# DART SERVICE BULLETIN SB10-6

D350-561-141 SINGLE MIRROR INSTALLATION AT CHANGE 002 OR EARLIER  
D350-561-143 DUAL MIRROR INSTALLATION AT CHANGE 002 OR EARLIER

REF FAA STC: SH856NE  
REF TCCA STC: SH91-20  
REF EASA STC EASA.IM.R.S.01516

**FIGURE 1**

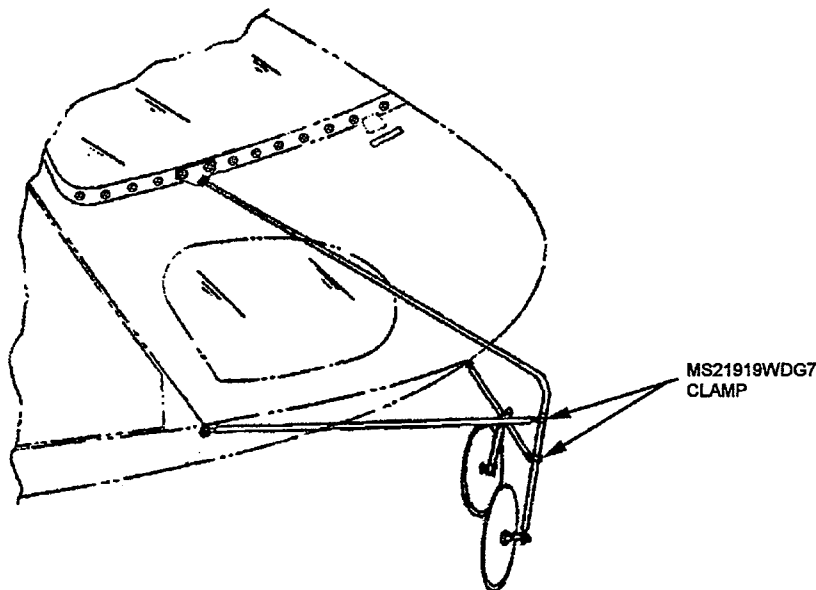
For D350-561-141/-143 mirror kits, the MS21919WDG7 clamps have been replaced with stonger D4070-041 clamps. For customers with D350-561-141/-143 mirror kits at change 002 or earlier, it is recommended that the MS21919WDG7 clamps be replaced with D4070-041 clamps.

The DSI-9379-013 kit is available from DART to upgrade affected installations. Please see Dart Service Instruction **DSI 9379 Rev. C** (or later revision) for further information.
